# GROTTO ENGINEERING ASSOCIATES, LLC

April 26, 2024

Subject: Completeness Review No. 3  
Home & Land Development Corp.  
14 & 32 North Peak Street  
Block 35, Lots 8 & 9  
Borough of Highlands, Monmouth County, New Jersey  
Our File No.: PR-0290

1. HLPB2022-10 - COMPLETENESS REVIEW #3 – (February 20, 2024) – Carmela Roberts, P.E., C.M.E., C.P.W.M., Land Use Board Engineer

**CUT FILL CALCULATIONS:**

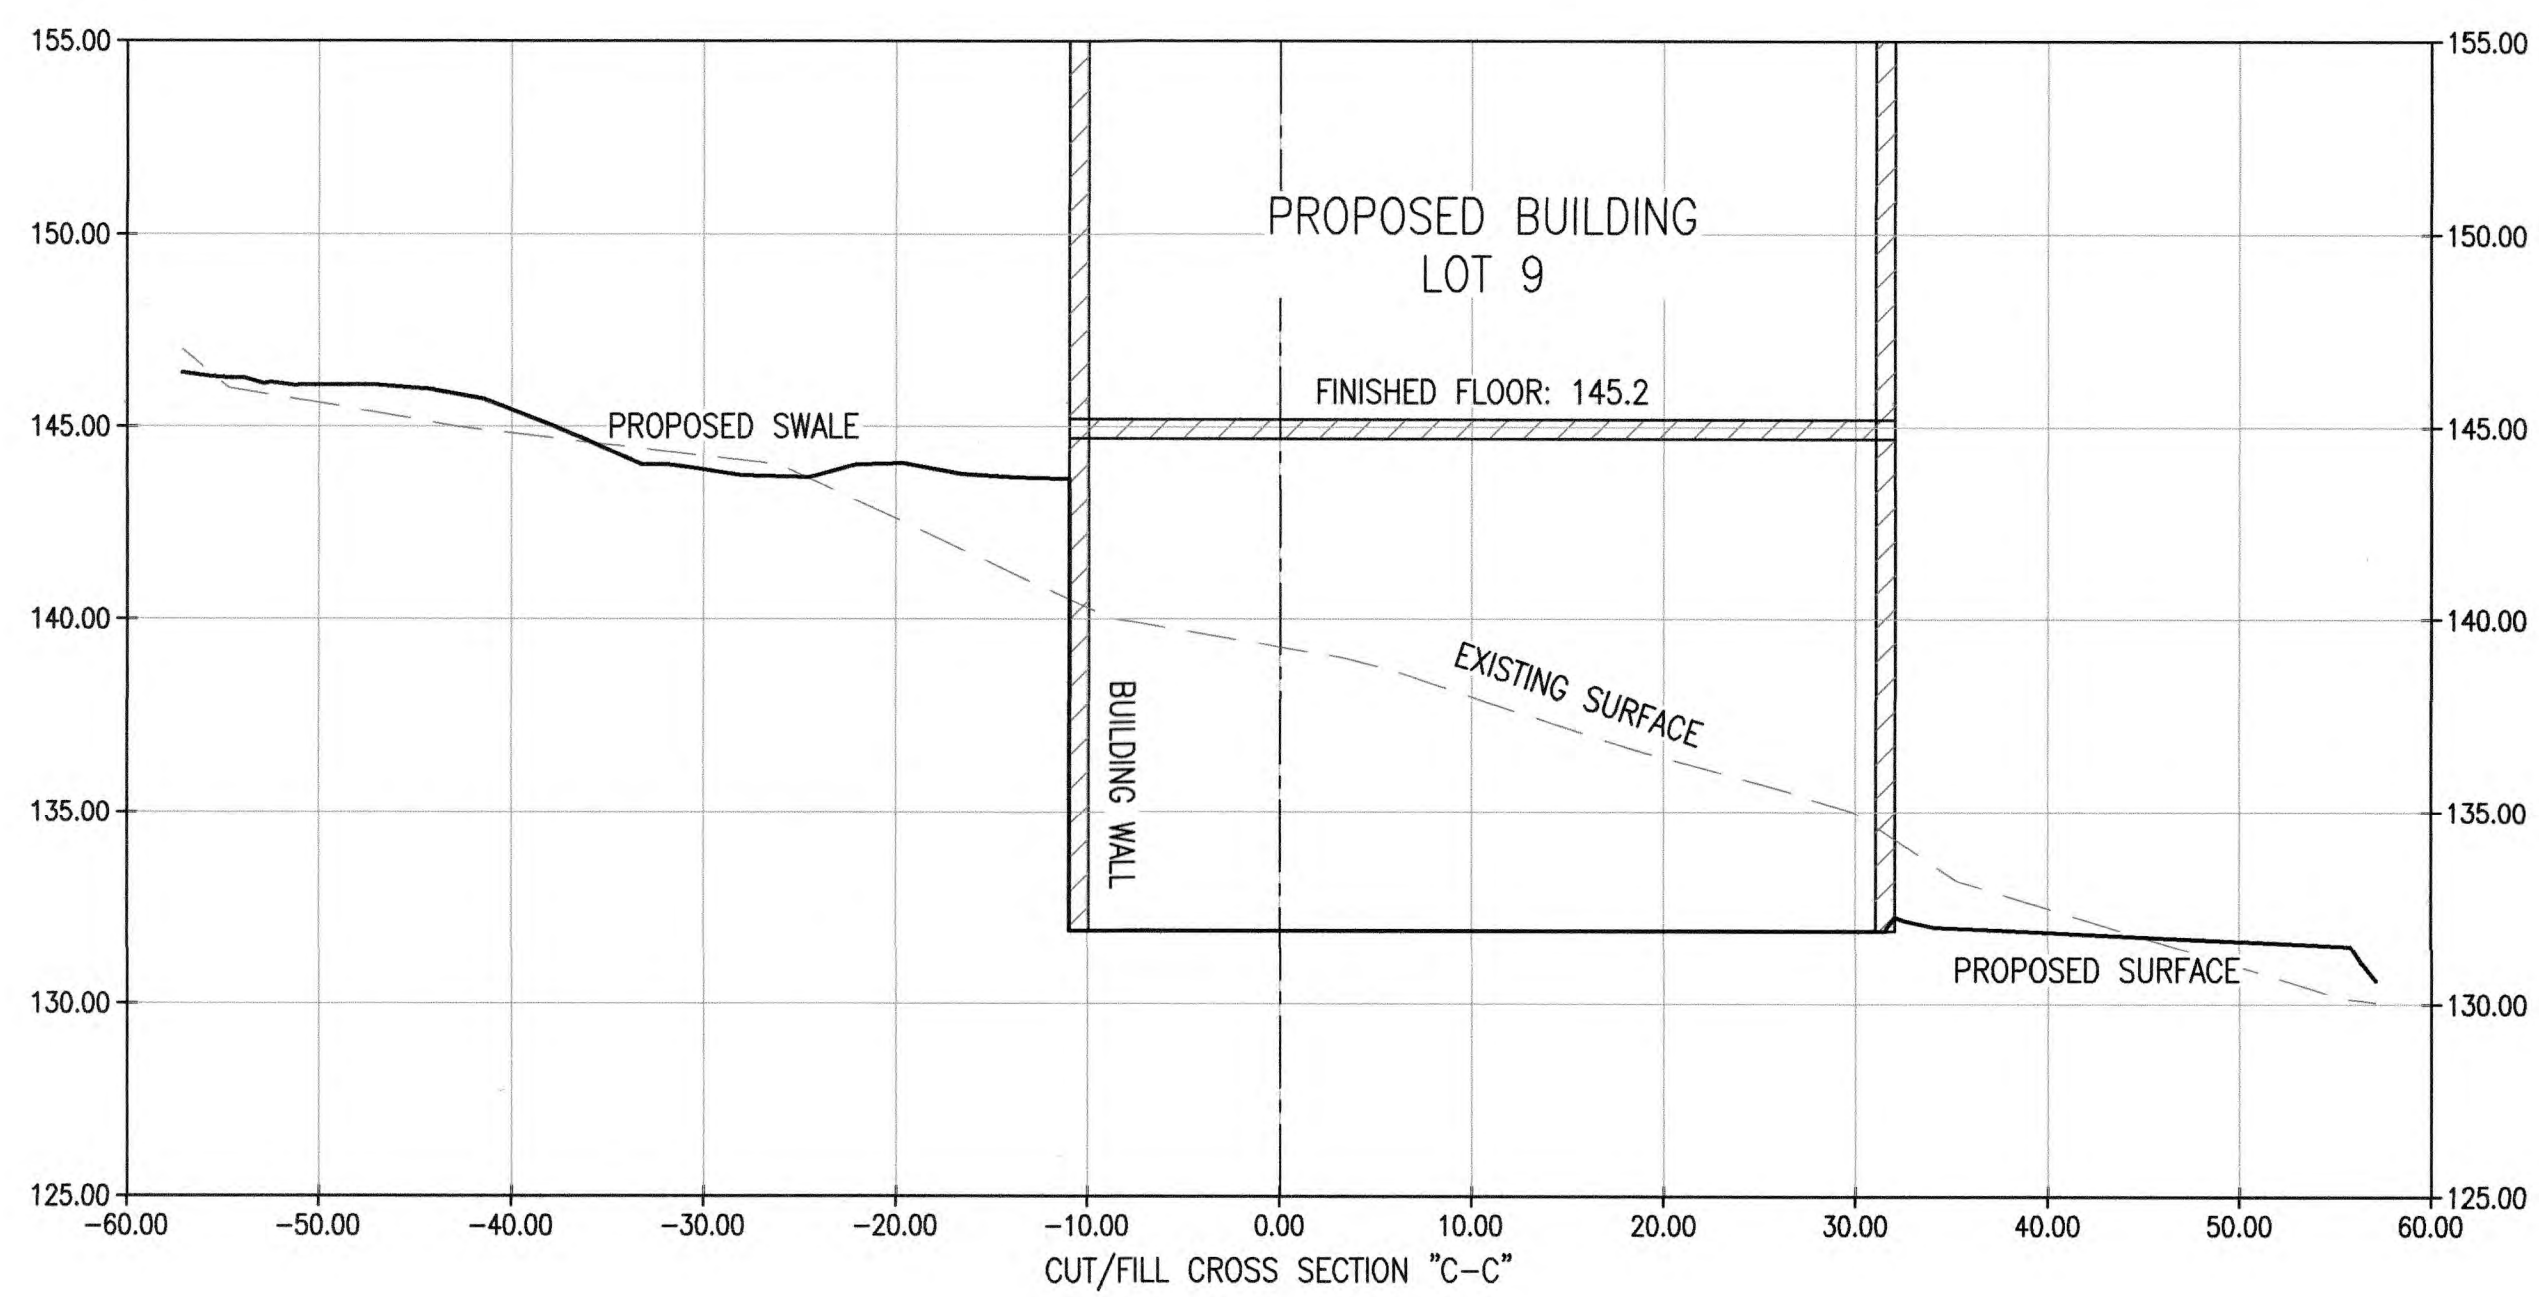
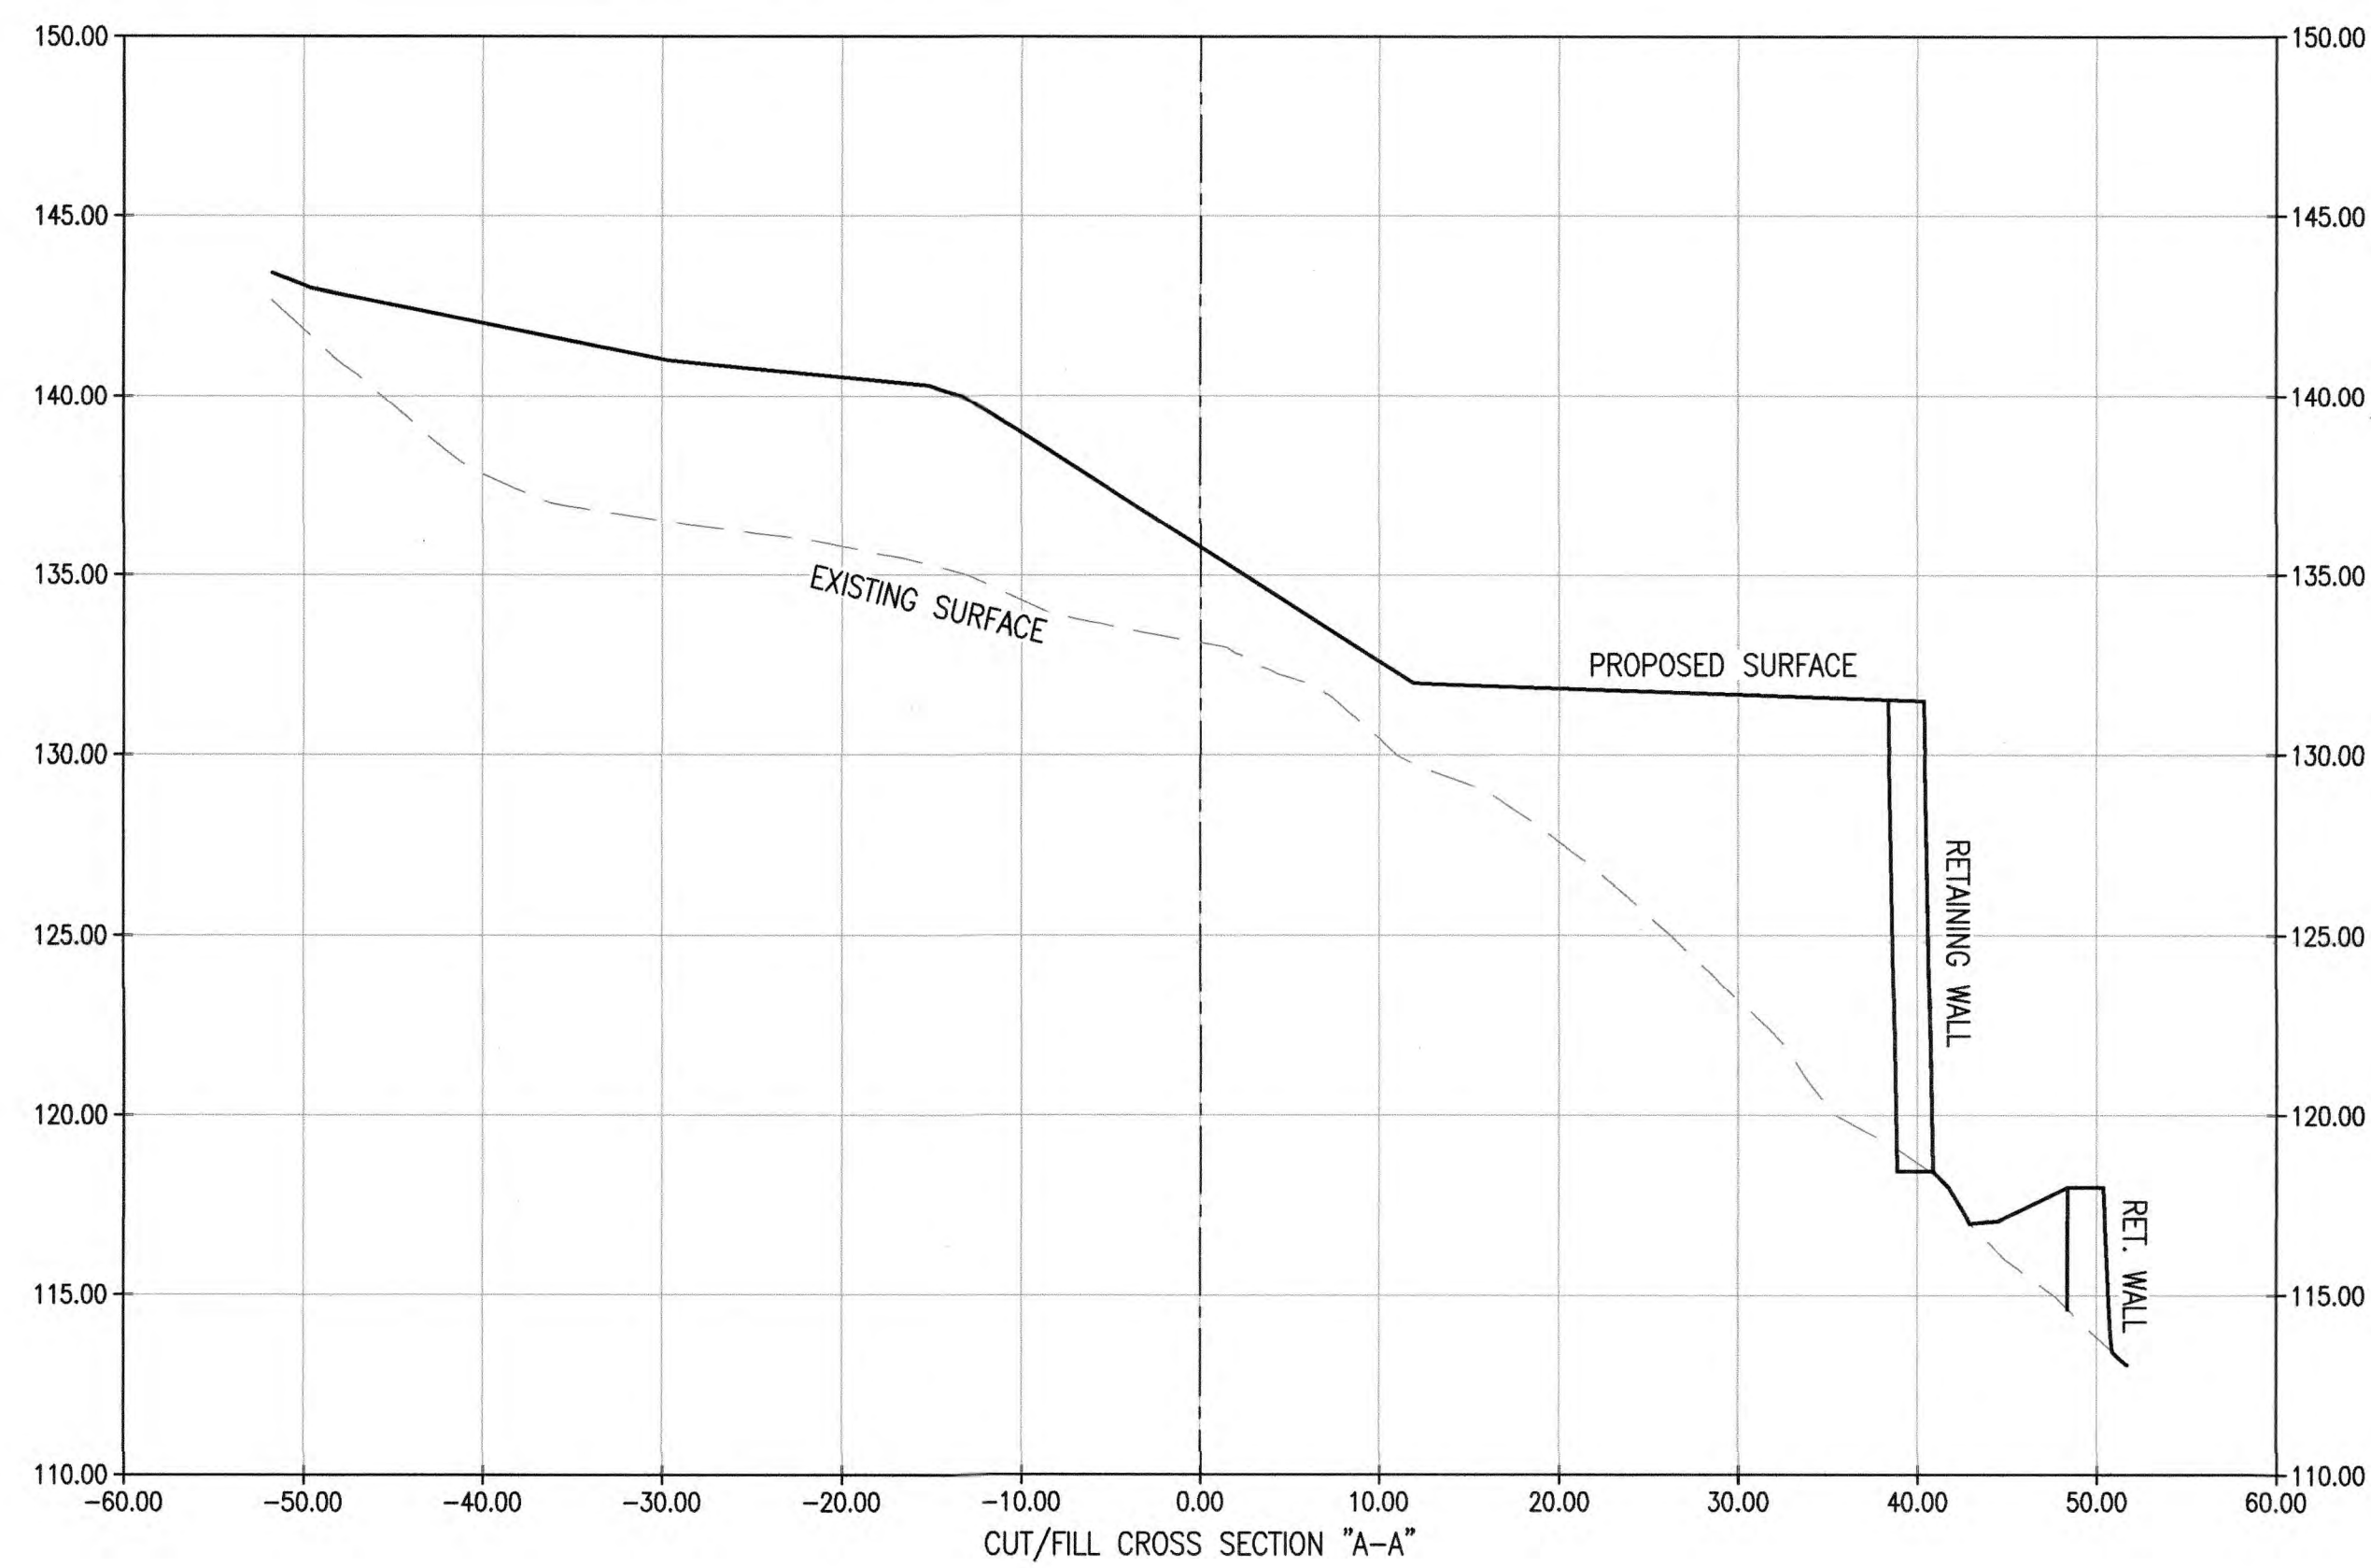
- l. Calculation of amount of site grading, to include a cut-and-fill balance sheet, including cross sections, and indicating, where applicable, the volume of and source of off-site fill.

**Cut-and-fill cross sections and calculations are provided on sheet 6 of the accompanying plans. Source of fill is to be determined.**
